ADDENDUM NO. 1

BURNETT FERRY ROAD IMPROVEMENT BID NO. 031-16

October 20, 2016

TYPICAL SECTIONS

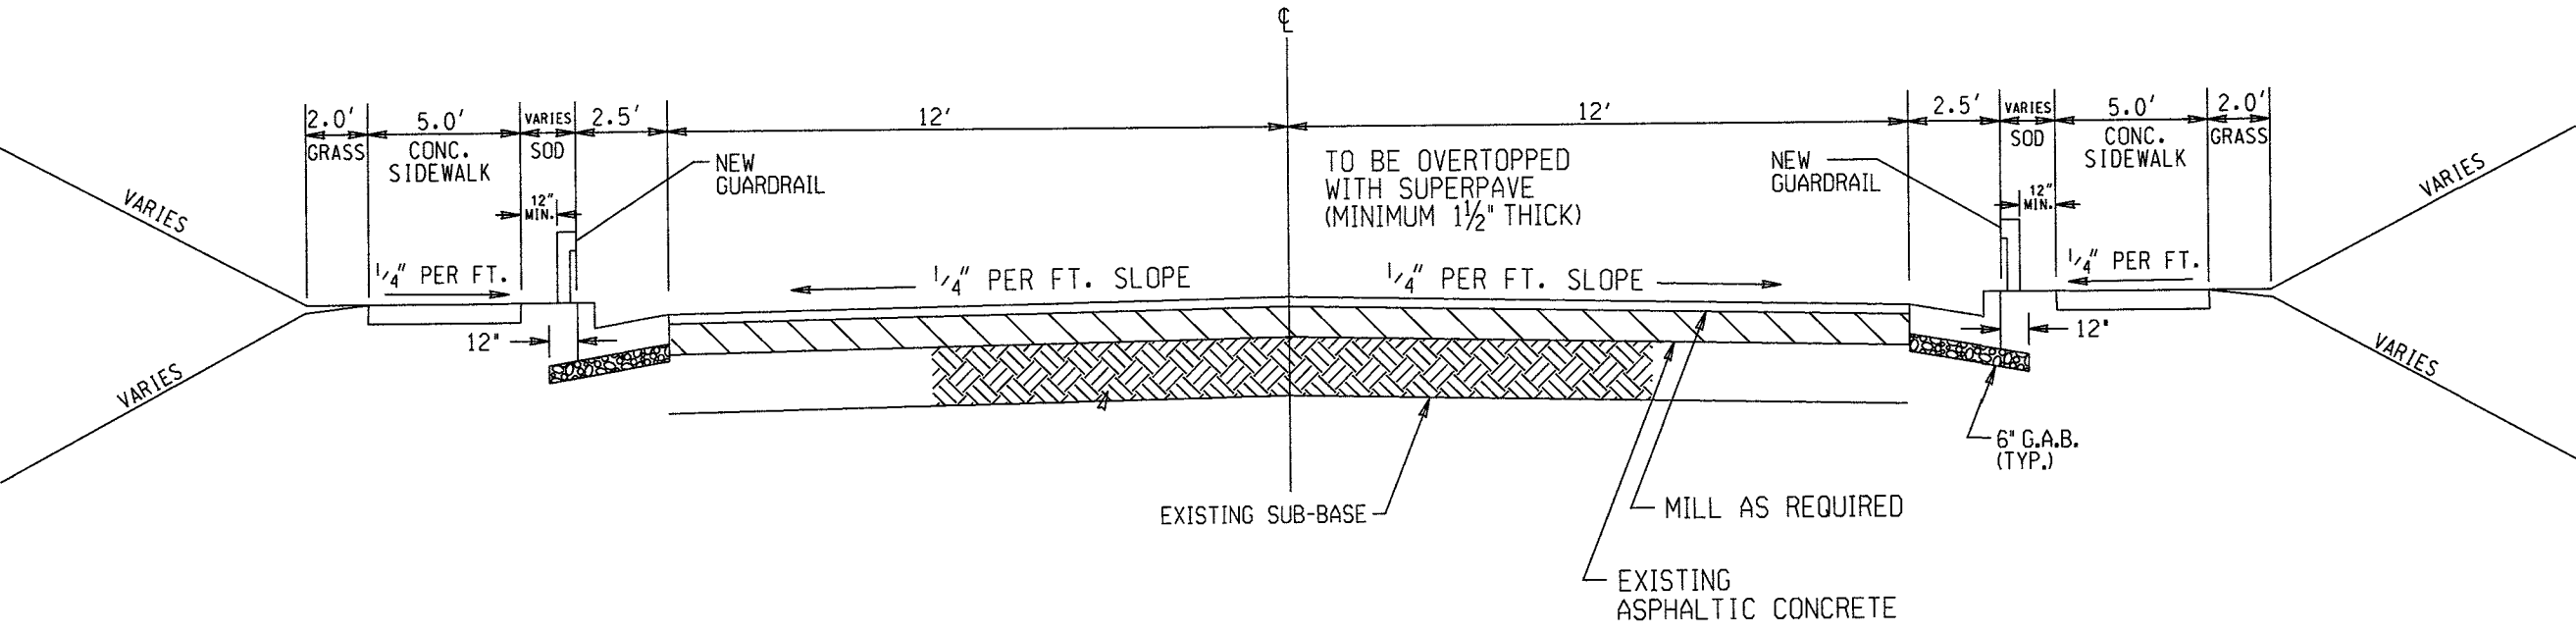
Revised Sheet 5-01 Typical Sections Revised
Revised Sheet 13-05 Added CB-67
Revised Sheet 13-05 Added CB-66, CB-65, FES-17, Additional Storm Drain, Adjusted Milling Limits, Added new Guard Rail
Revised Sheet 22-01 Added Profile Information
Revised Sheets 23-11 to 23-13 Grade Changes to Roadway
Revised Sheets 54-05 to 54-06 Revised BMP's to reflect additional Drainage Structures
Revised Sheets 55-04, 55-06 to 55-08 Revised "Typical Curb and Gutter Section along Burnett Ferry Road", Added Details associated with addition of Guard Rail to project.

TYPICAL ROADWAY SECTION
STA. 256+71 TO STA. 299+28
STA. 301+08 TO STA. 313+02
SCALE : NOT TO SCALE

TYPICAL ROADWAY SECTION WITH GUARDRAIL
STA. 299+28 TO STA. 301+08
SCALE : NOT TO SCALE
